**Town of Breckenridge**  
**Planning Commission Agenda**  
Tuesday, December 7, 2010  
Breckenridge Council Chambers  
150 Ski Hill Road

PLANNING COMMISSION MEETING

**PRELIMINARY UTILITY AND DRAINAGE PLAN**

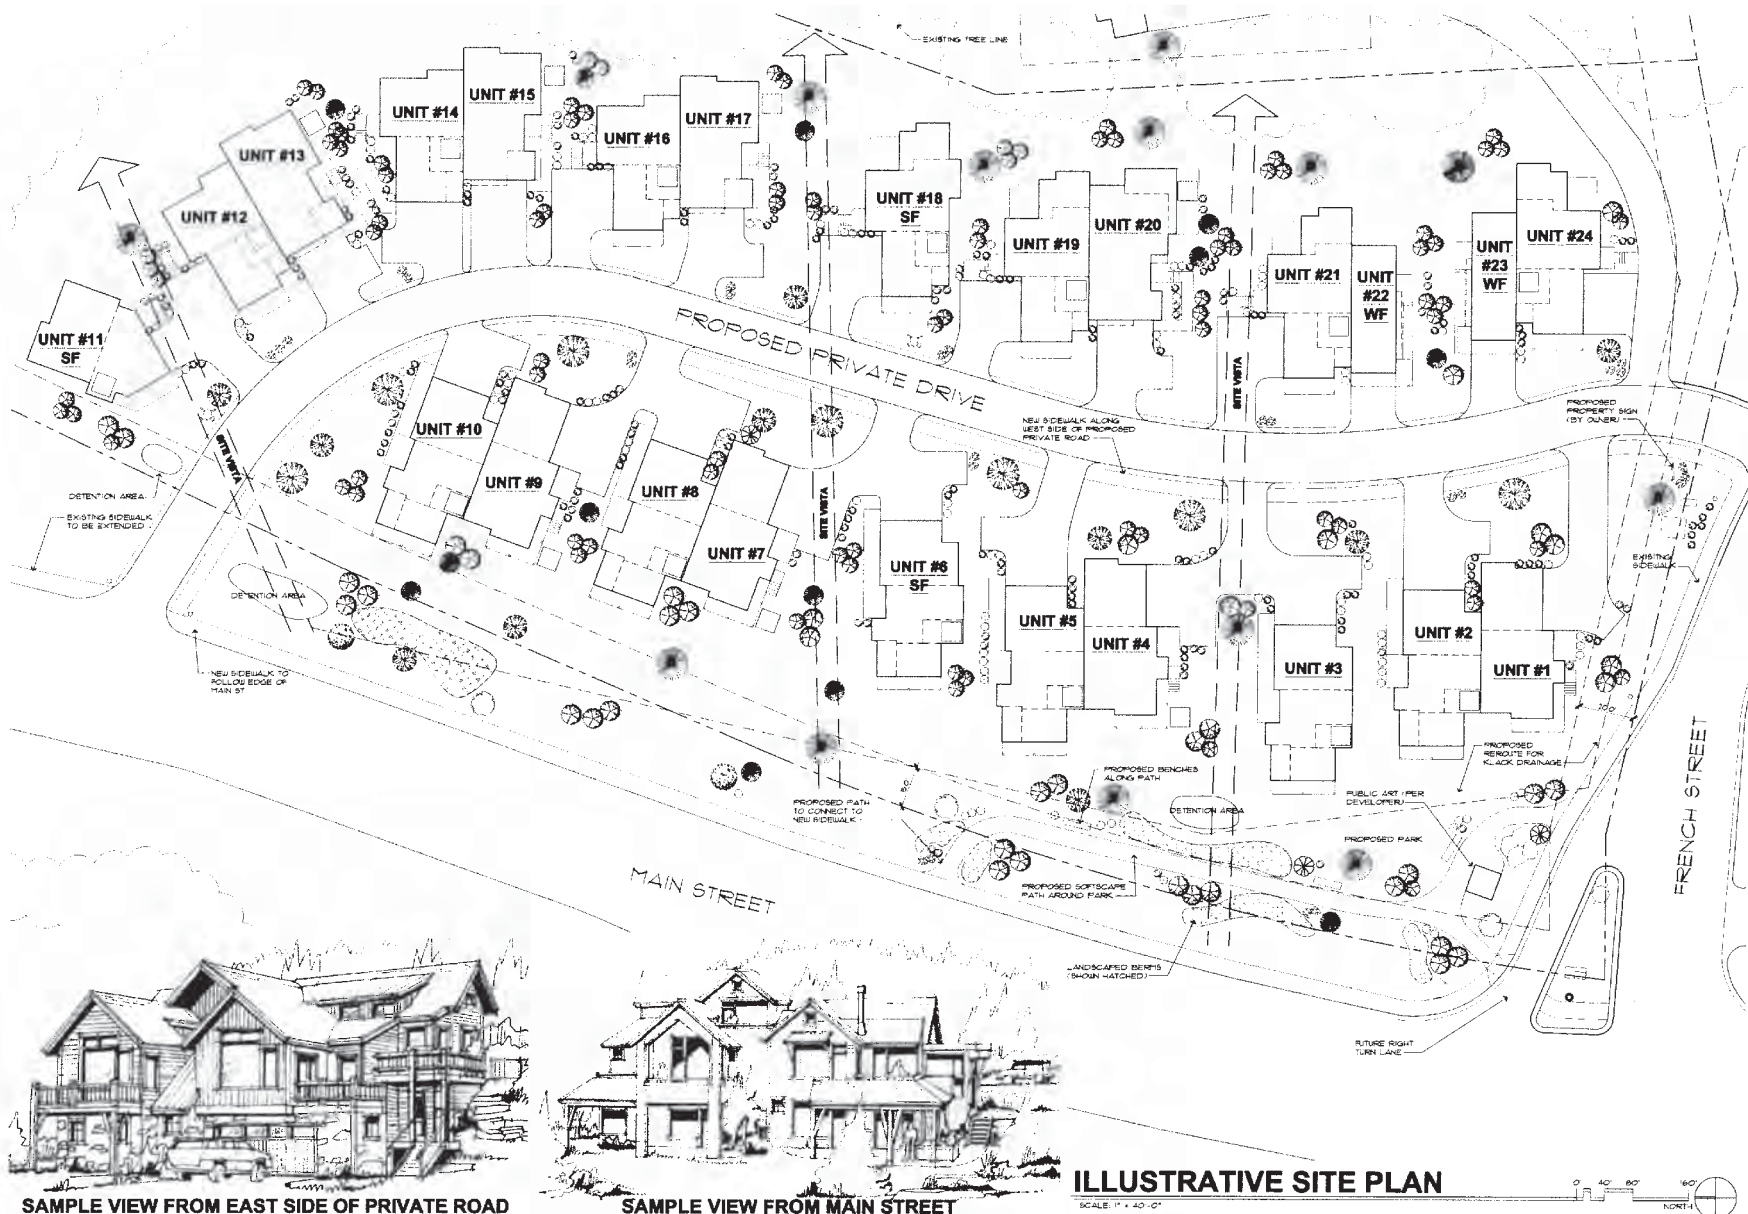
**Utilities Infrastructure (26/A & 26/R; 28/A):** Sheet MP-4 delineates the preliminary utility plan for the multi-family development. Staff has no immediate concerns. More detail will be reviewed at the next meeting

**Drainage (27/A & 27/R):** Sheet MP-3 depicts the preliminary drainage and infrastructure plans for the development. Staff has no immediate concerns. More detail will be reviewed at the next meeting

SHEET NUMBER: A1.11

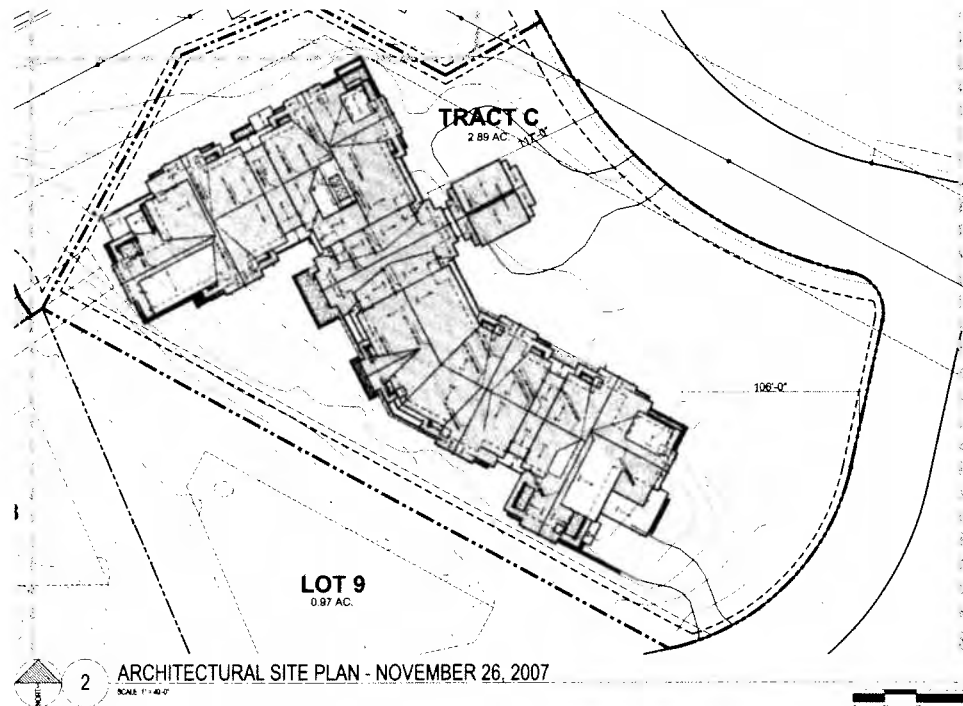
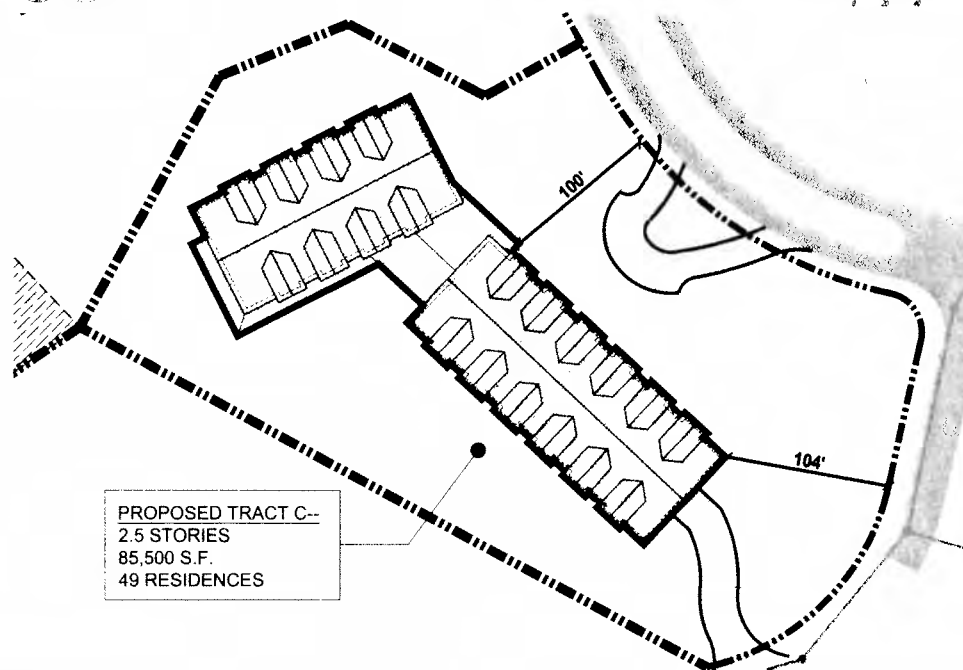
**Placement of Structures (9/A & 9/R):** All required setbacks have been met. Staff finds the location of the building “substantially similar” to the location shown in the approved development agreement (see Sheet A1.11). The Commission will need to agree that this plan is substantially similar to the site plan exhibit in the approved Development Agreement in order to approve this project.

SHEET NUMBER: A1.11

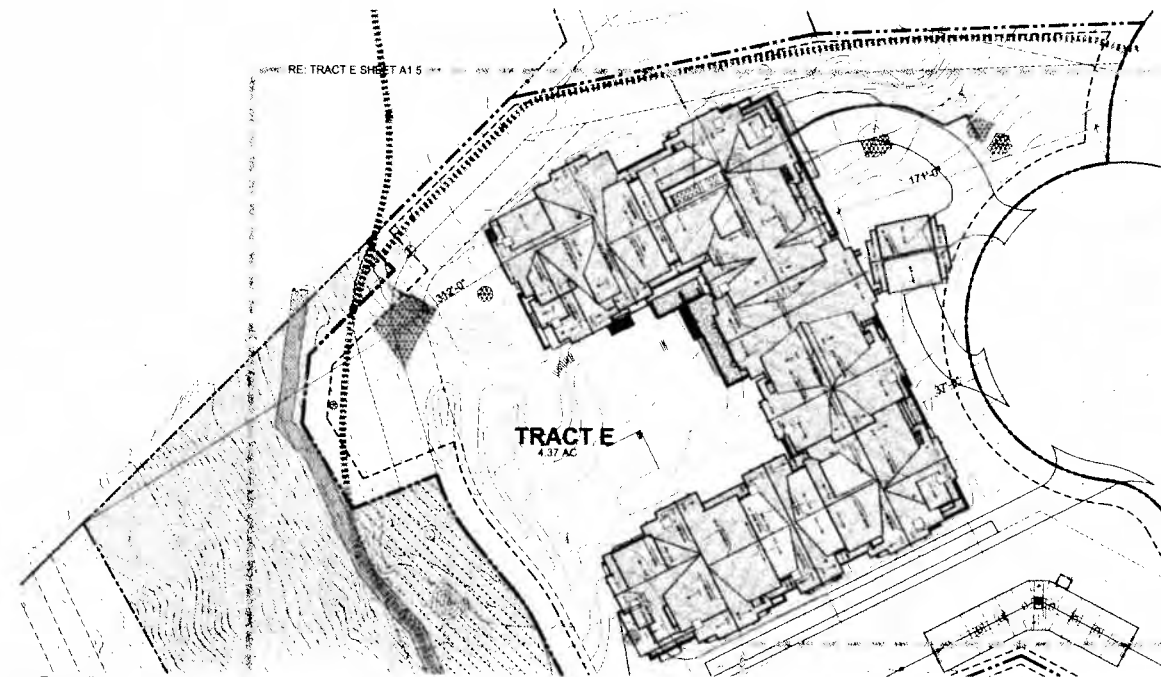
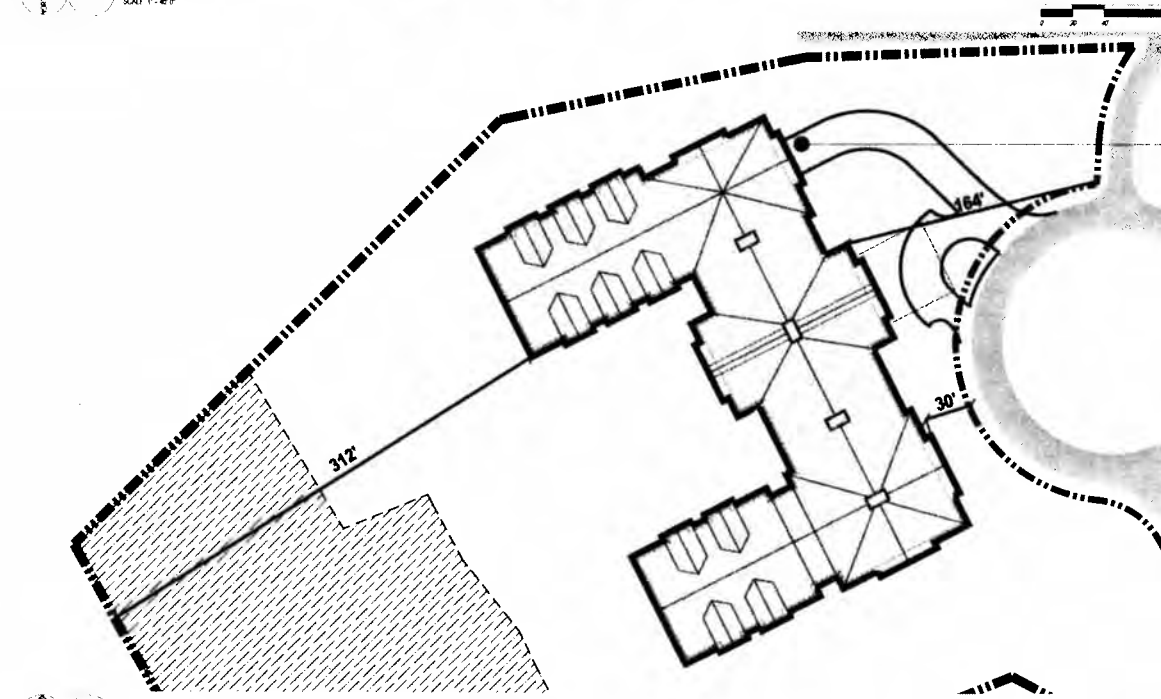
**Site Plan:** No changes are proposed to the site plan. The footprint location substantially matches the exhibit in the Development Agreement, and is exactly the same at the rear of the building, which is 312' from the Gulch. (See Sheet A1.11)

the Development Agreement (Sheet A1.11), the building was shown approximately 30' from the right of way, and is now proposed about 37' away, except for the porte-cochere. The main body of the building was 164' from the eastern property line, and is now 171'. Most importantly, the rear setback (from Cucumber Gulch) was 312' in the agreement, and is now 312'.
